RE: Agency Review Comments and Request for Additional Information, Summa Silver Mogollon Project, Catron County, New Mexico, Permit No. CA27EM

Summa Silver has reviewed the comment letters submitted as part of our Part 3 Minimal Impact Exploration Permit Modification and Renewal. We have identified the following comments and have the subsequent responses:

Figure 1: Revised Mogollon Project Extent Map depicting land ownership, drill pad, and access road locations.

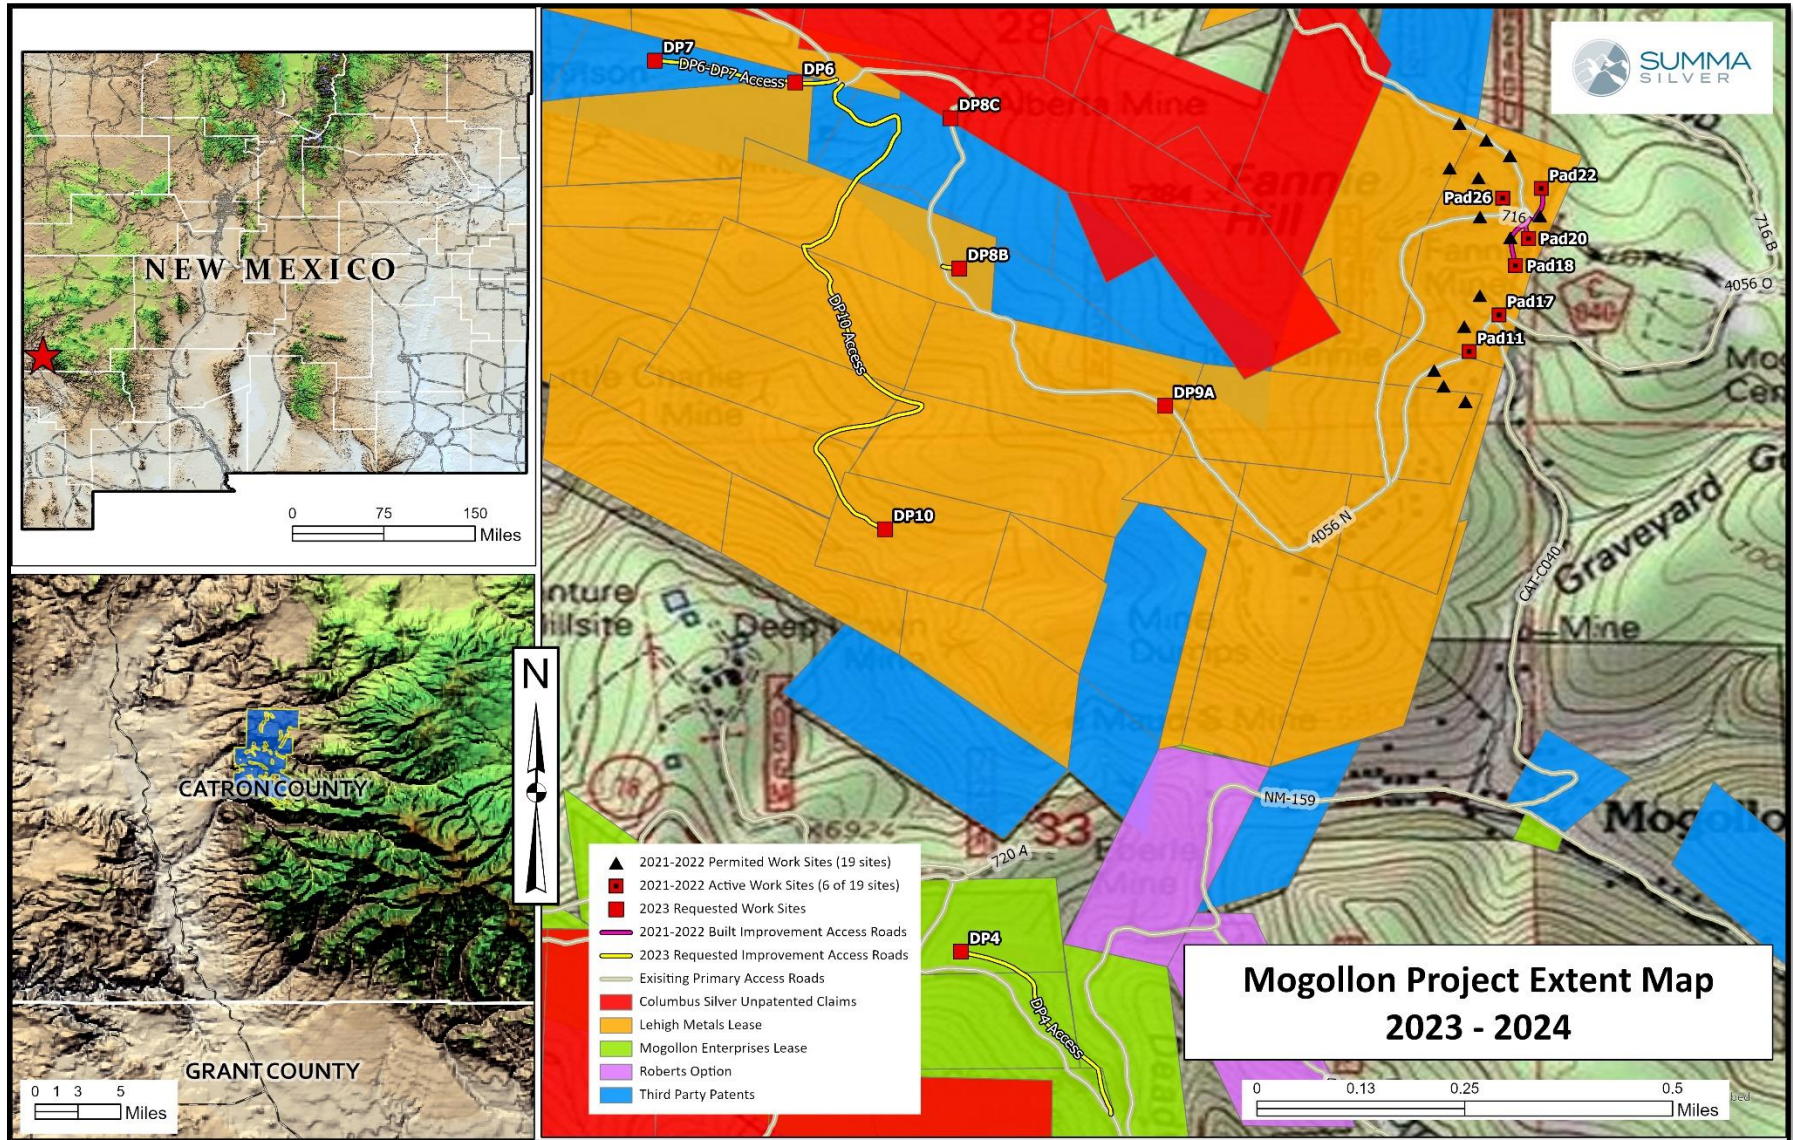
During site visits conducted on June 26 and July 26, 2023, it was stated by Summa that proposed drill pads DP8A, DP12, and DP13 were to be removed from the PAP due to proximity with registered historic districts and/or artifact sites. Please confirm that these drill pads have been removed from the PAP and state if any other drill pads, access roads, or any other form of permitted disturbance are to be removed from the PAP.

During site visits conducted on June 26 and July 26, 2023, it was noted that proposed access routes along historic roads to DP6/DP7 and DP10 are in some sections totally reclaimed by native vegetation and slopes. The condition of these routes would require new road construction as opposed to extension or widening of an existing usable road. Please recalculate estimated disturbance acreage due to new road construction.

State and show which previously permitted drill pads, borings, and access roads have been constructed and the reclamation or abandonment status of each.

In the 2021 PAP and the current PAP, there are several different road widths included for estimated disturbance due to new road construction and existing road improvement ranging from 5 to 14 feet in width. For the purpose of disturbance estimation due to road construction or improvement, the entire road width should be included in the calculation, and road width should not vary widely across a permit unless there is a different purpose or equipment usage planned. Please clarify road width for all proposed and previously permitted new road construction and existing road improvement and recalculate total estimated disturbance as necessary. If a section of road will vary in width from the majority of proposed roads, please state the reason for the variation.

Summa Silver confirms that drill pads DP8A, DP12, and DP13 have been removed from the PAP due to proximity with registered historic districts and/or artifact sites. Consequently, the proposed access roads to drill pads DP 12 and DP 13 have also been removed from the PAP. The recalculated estimated disturbance acreage due to drill pads is 0.401 acres. Recalculated estimated road disturbance totals are discussed below. An updated map (Figure 1, Page 12) and revised PAP are included in addition to this response memorandum.

The PAP has been revised to reflect the recalculated estimated disturbance acreage due to new road construction as well as the removal of drill pads and associated roads discussed in our response to MMD Comment #1. The recalculated estimated disturbance acreage due to new road construction is 1.192 acres.

An updated map (Figure 1, Page 12) and revised PAP are included in addition to this response memorandum.

Previously permitted drill pads 11, 17, 18, 20, 22, and 26 have been constructed, including existing road access improvements to the listed drill pads, and no new road construction has occurred. No reclamation has occurred because drilling activities at each constructed drill pad are ongoing. Reclamation will occur in accordance with permit stipulations once drilling activities have been completed. An updated map (Figure 1, Page 12) and revised PAP are included in addition to this response memorandum.

Road width for all proposed and previously permitted new road construction and existing road improvement will be 10 feet. The PAP has been revised to reflect the recalculated estimated disturbance acreage. To summarize revised project disturbance estimates, the recalculated estimated disturbance acreage due to existing road improvement is 0.322 acres and 1.192 acres for new road construction, resulting in a recalculated estimated road disturbance total of 1.514 acres. Including a recalculated estimated disturbance acreage due to drill pads (0.401 acres), the revised total acreage to be disturbed relative to this permit modification request is 1.914 acres. Our currently approved permit allows for 1.350 total acres of disturbance; therefore, our total estimated project disturbance is 3.264 acres upon approval

of this modification request. An updated map (Figure 1, Page 12) and revised PAP are included in addition to this response memorandum.
